Well Name: BIG EDDY UNIT DI BB JABBA	Well Location: T20S / R32E / SEC 22 / SWSW / 32.55275 / -103.760482	County or Parish/State: LEA / NM
Well Number: 102Y	Type of Well: OIL WELL	Allottee or Tribe Name:
Lease Number: NMLC065750A, NMNM33955	Unit or CA Name: BIG EDDY	Unit or CA Number: NMNM68294X
US Well Number: 3002547226	Operator: XTO PERMIAN OPERATING LLC

WELL RECORD CLEANUP

Subsequent Report

Big Eddy Unit DI Jabba 102Y
30-015-47226

Schematic - Vertical with Perfs

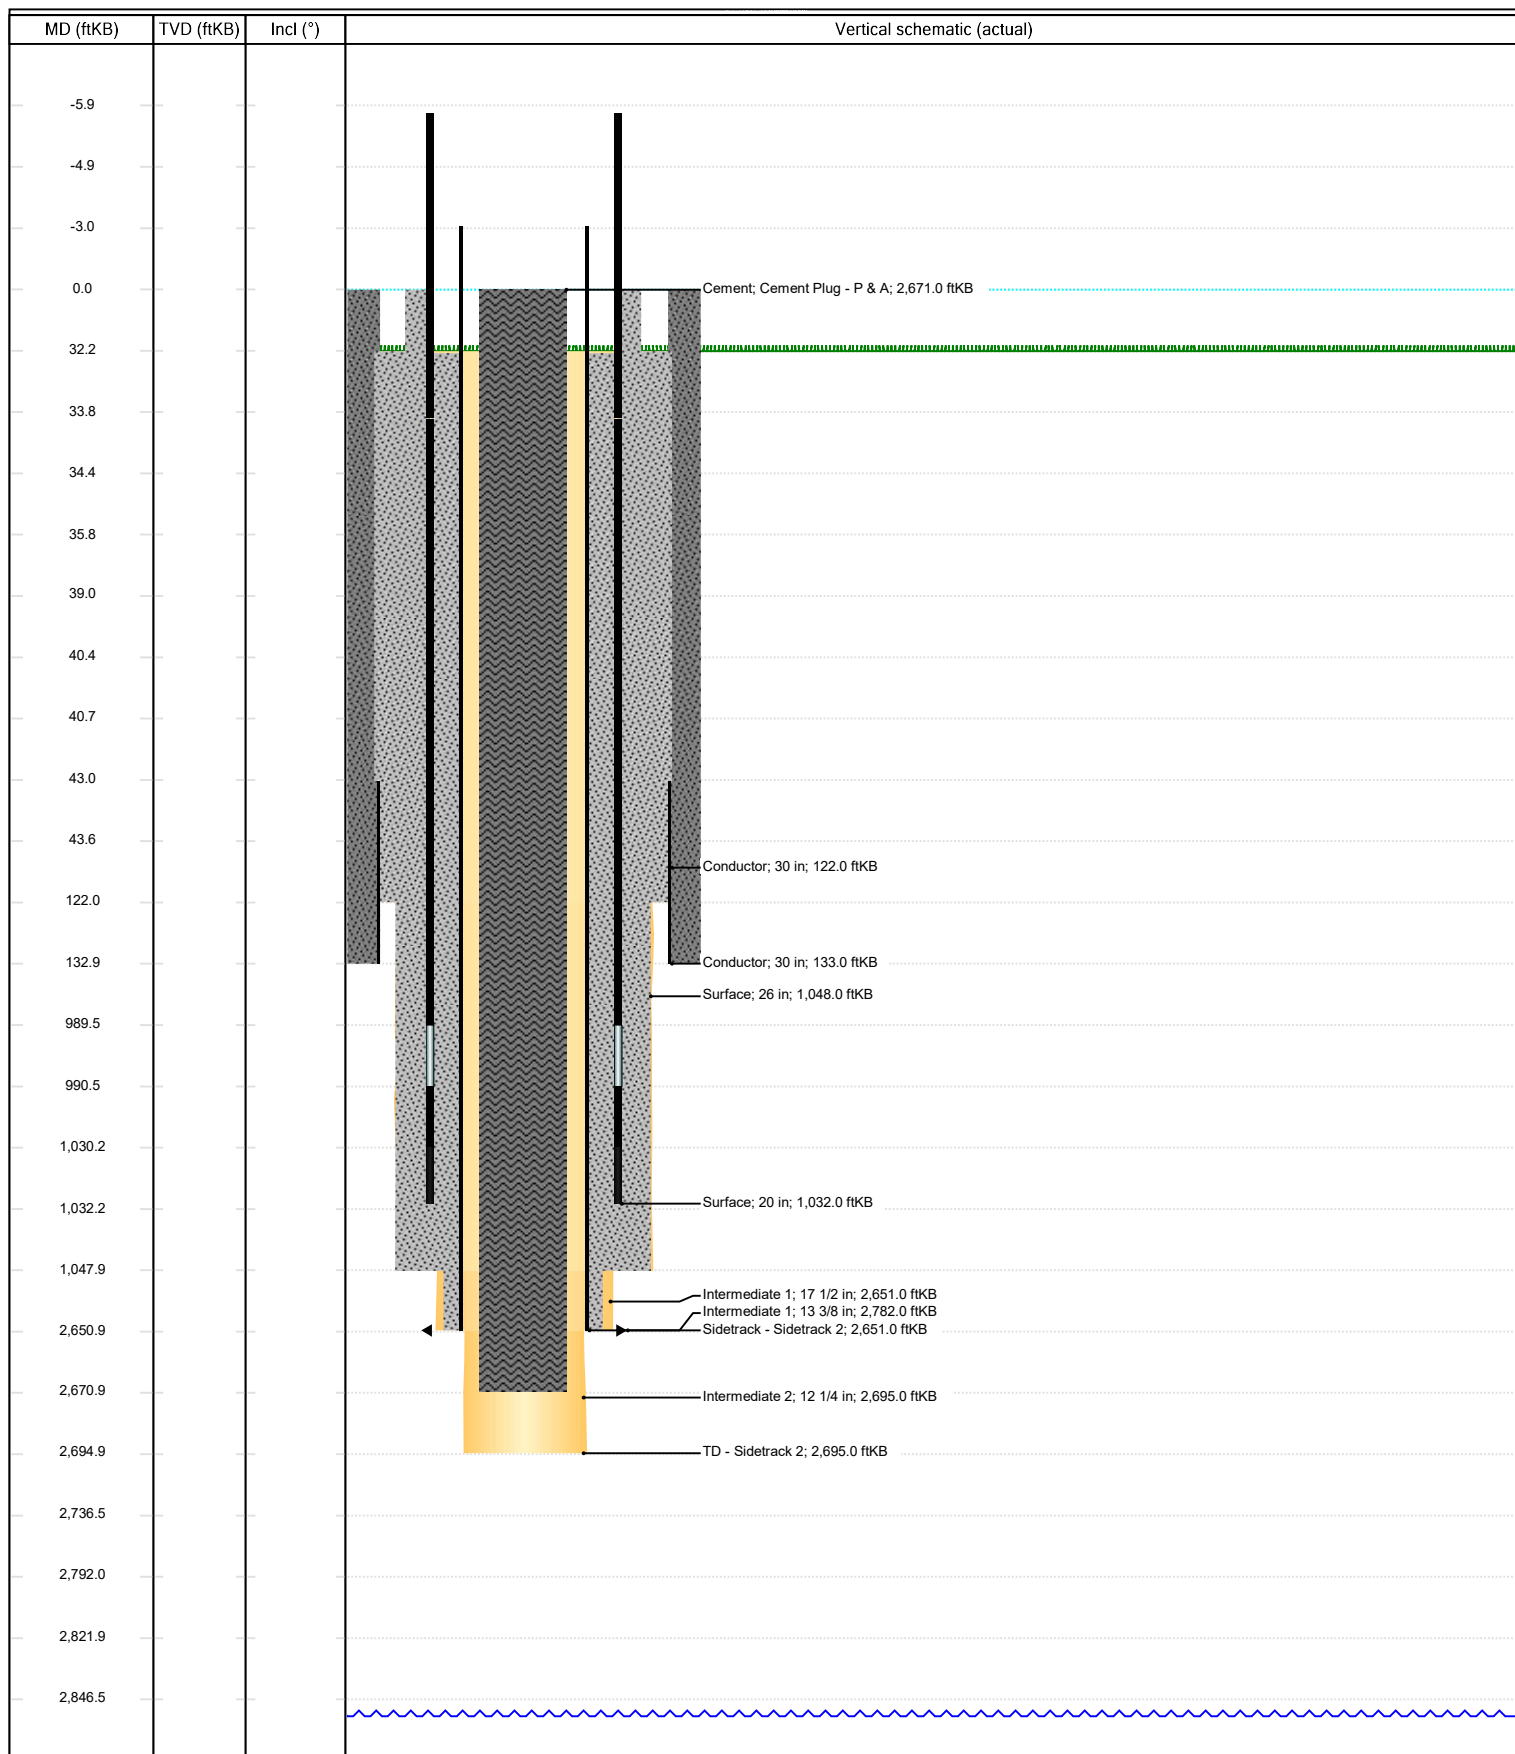
Summary of changes:

- Corrected depth of well from 2820 ft to 2695 ft
- Will now pump salt isolation string as two plugs in order to ensure competent cement
- Will now pump surface isolation string as two plugs in order to ensure competent cement
- Corrected depths of plugs based on actual depth and geometry of the well

Reviewed and is OK.
